*Flowserve – Anchor Darling
Swing Check Disc Pin Failure*

Swing Check Disc Pin Failure

Figure 1 – Disc Back Impact, Disc Pin Failure

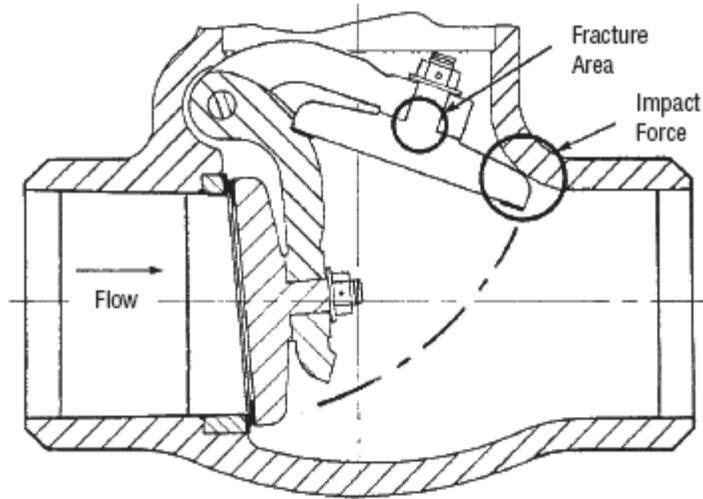
Based on detailed failure analyses, it is our conclusion that disc pin fractures are due to fatigue, not rotation. The direct impact of the back of the disc on the body during opening results in excessive stresses in the disc pin area (Figure 1). Repeated occurrences of this impact, due to frequent operation and/or disc flutter, are the cause of the fracture.

Figure 2 – Modified Hinge Design

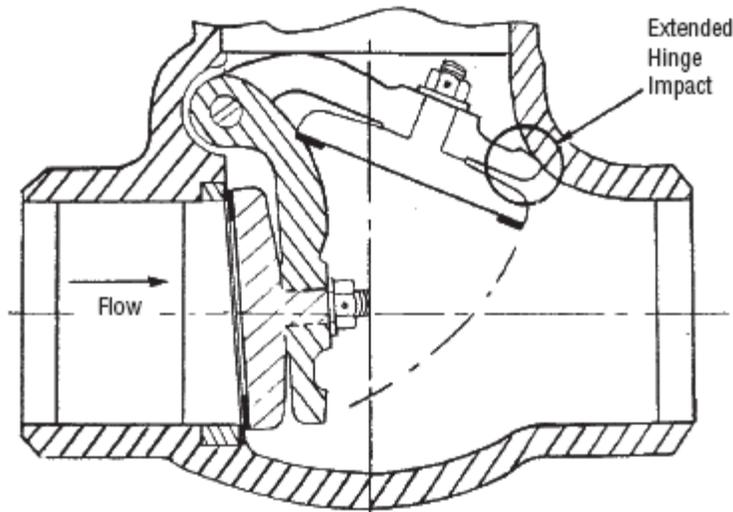
As a result of these findings, Anchor/Darling Valves modified its swing check valve design. The hinge has been extended to absorb the impact in the opening mode (Figure 2). This feature eliminates disc pin fractures while providing the disc flexibility essential to an extended seat life.
